#2020-00049

491 Golf Rd Special Use Permit

Project Review for Planning and Zoning Commission

Engineering Permit Review **OWNER COPY** *Crystal Lake*

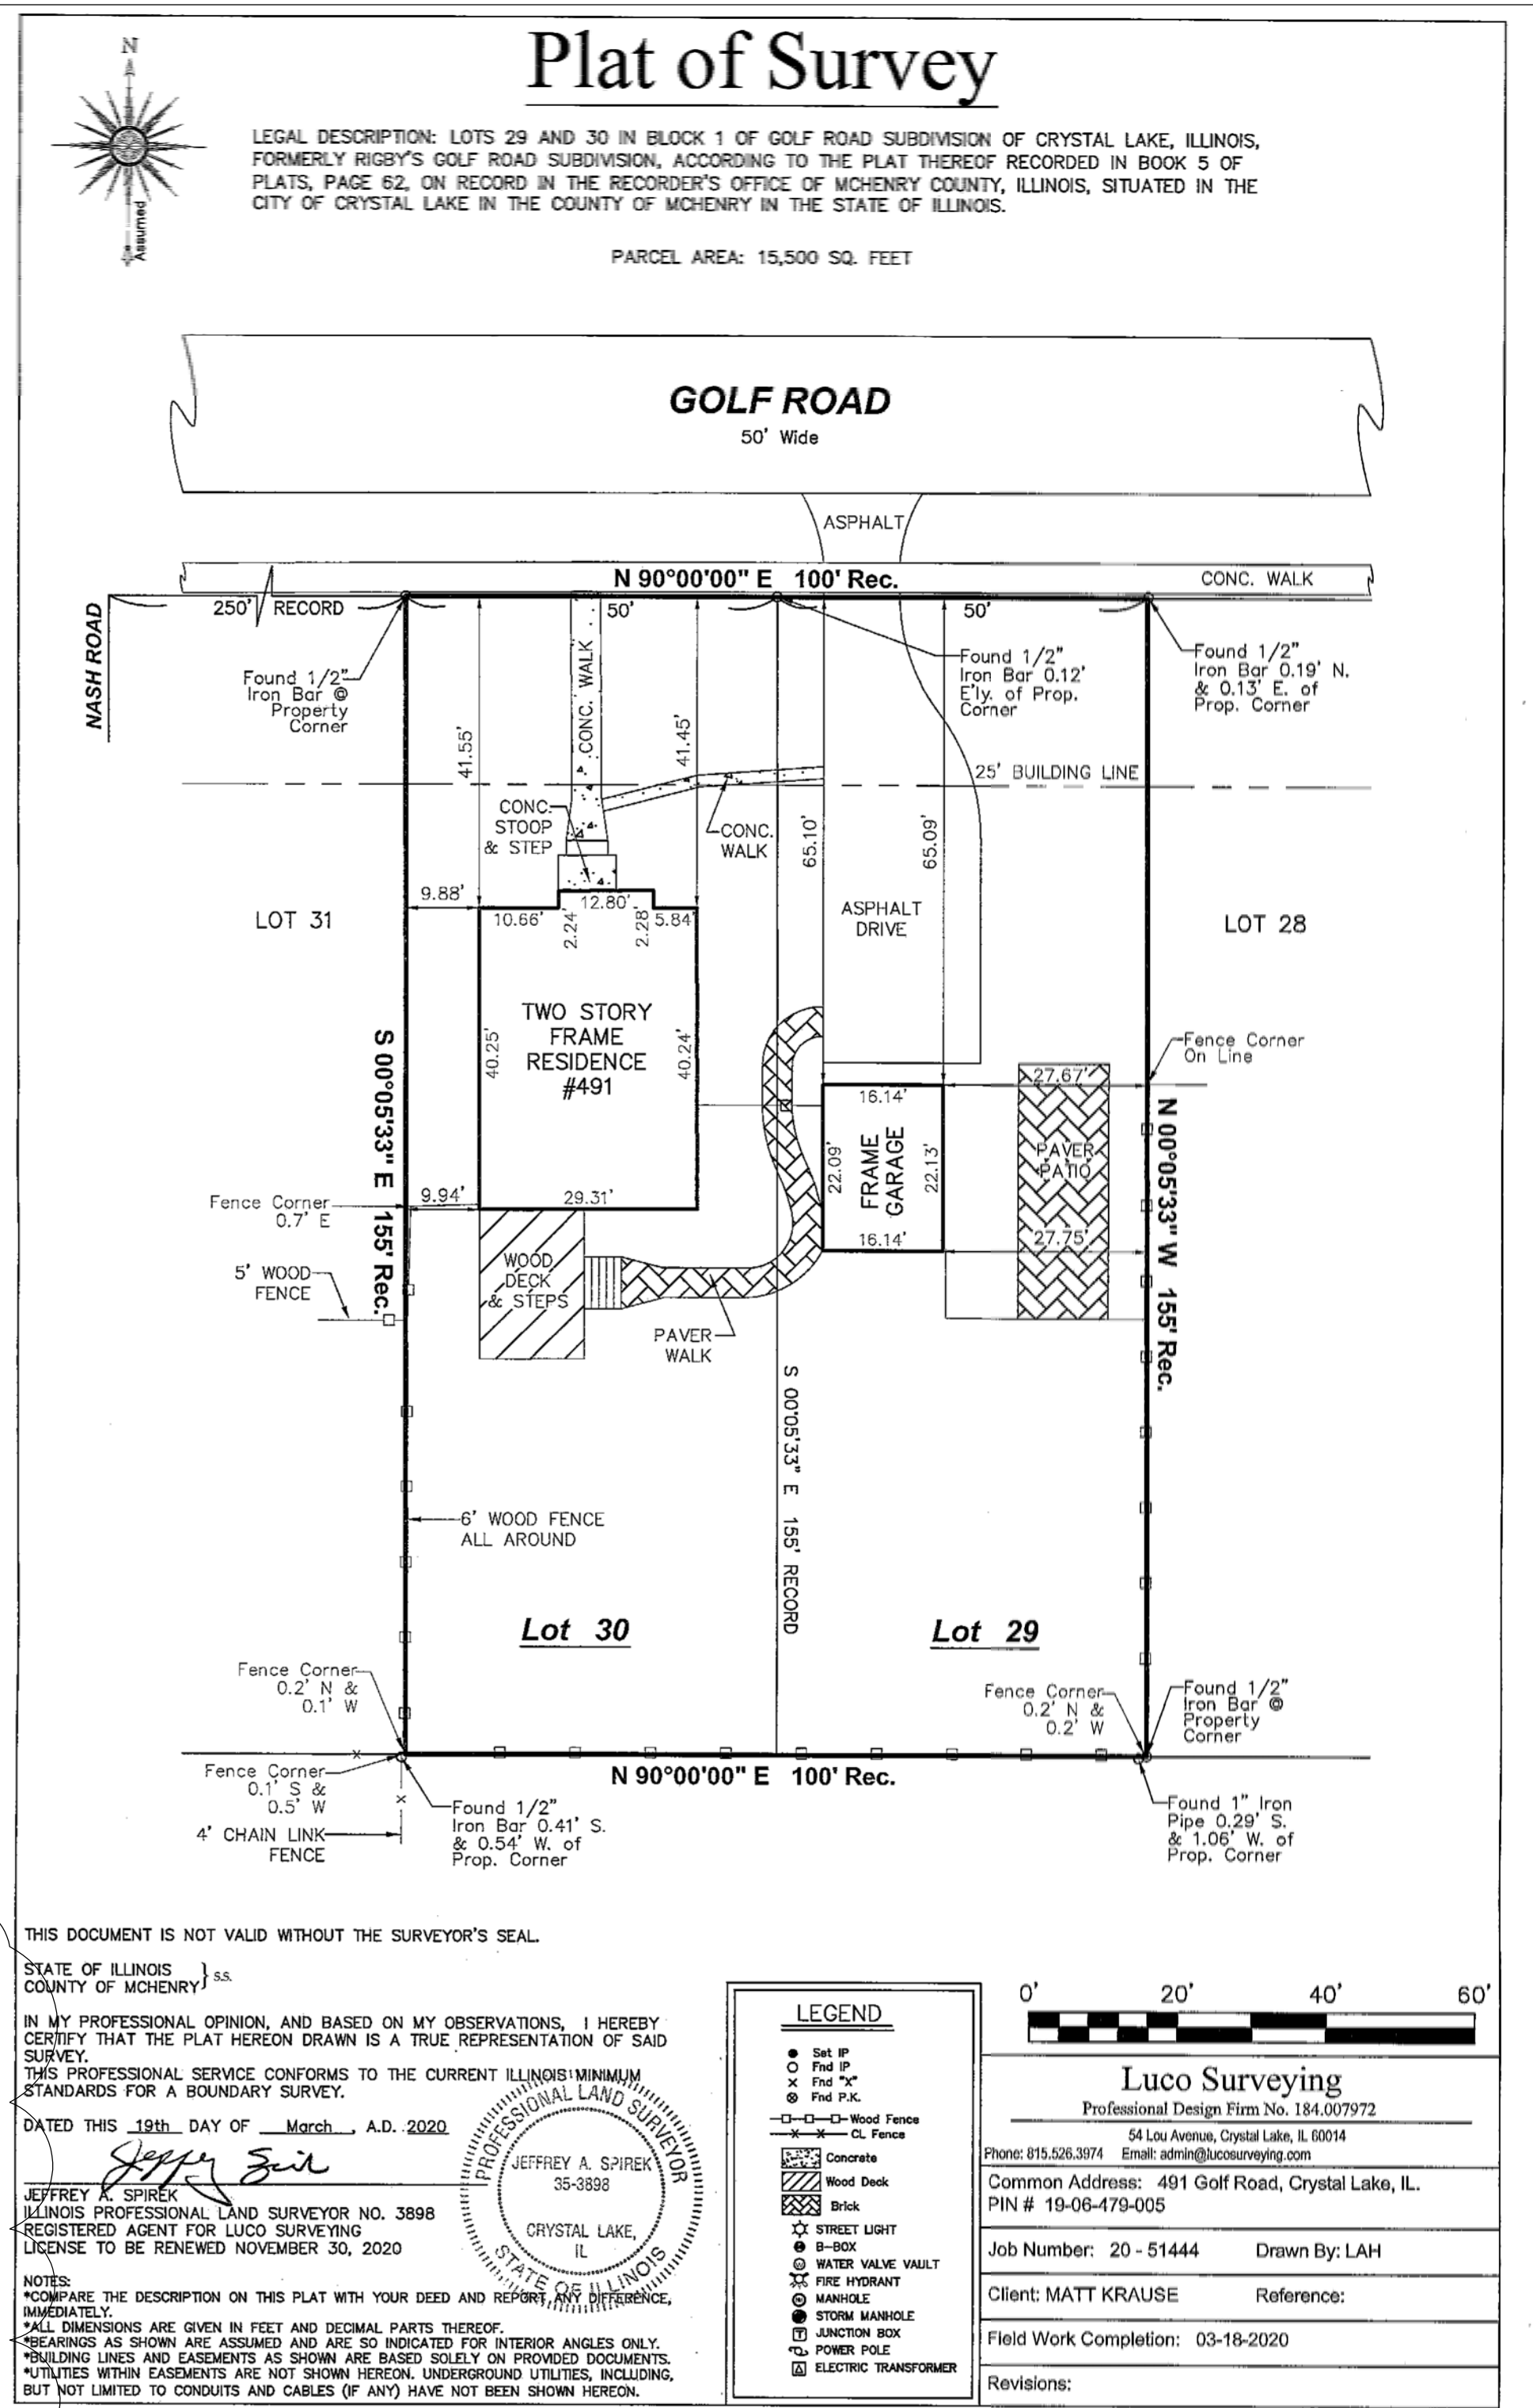
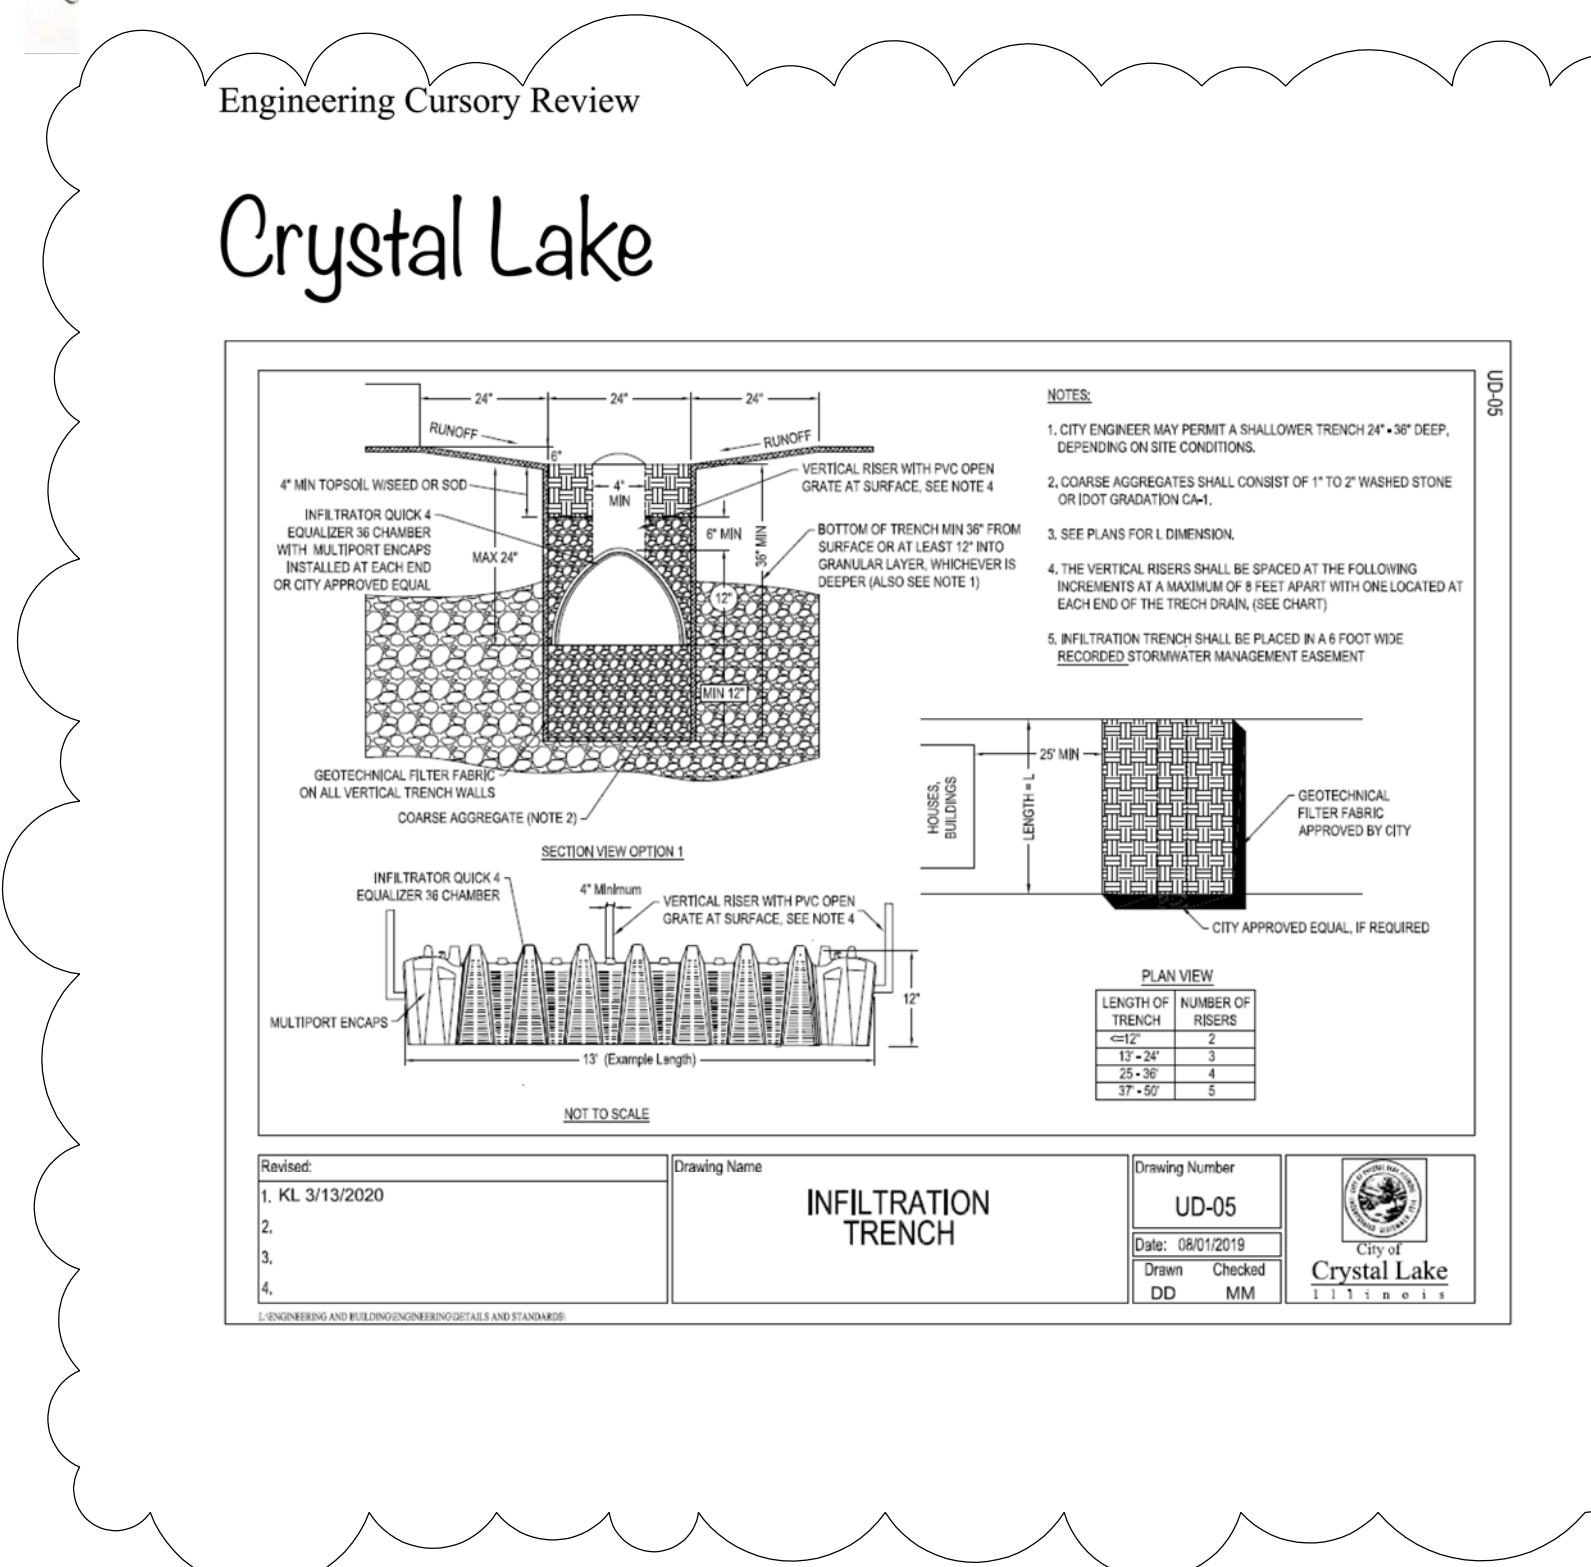
- Comments:
1. This property is located in the Crystal Lake Watershed and has been reviewed by one of our civil engineers. This parking pad is 12'x35' and is 420 square feet. Back in 2017 the owner added a paver walk and at that time built a 30' long trench drain in anticipation of this work. Only 14' trench drain was required for that walk so there was a credit of 16' which is equivalent to 800 square feet impervious. Including this improvement, there is still a credit of 380 square feet.

2. Be sure to remove black dirt in the area of the new parking pad.
 3. The pad must be a minimum of 5' from the property line.
 4. The base for the brick pavers is to be 4-6 inches of gravel with 1 inch of sand on top as bedding material for the pavers.

5. Do not store, stage, or dump materials into the street or right-of-way.
 6. The base material must be inspected before laying the pavers. Please call the Community Development Department at 815-356-3605 the day before the inspection is needed. Call for final inspection once the pad is completed and landscape restoration is done.
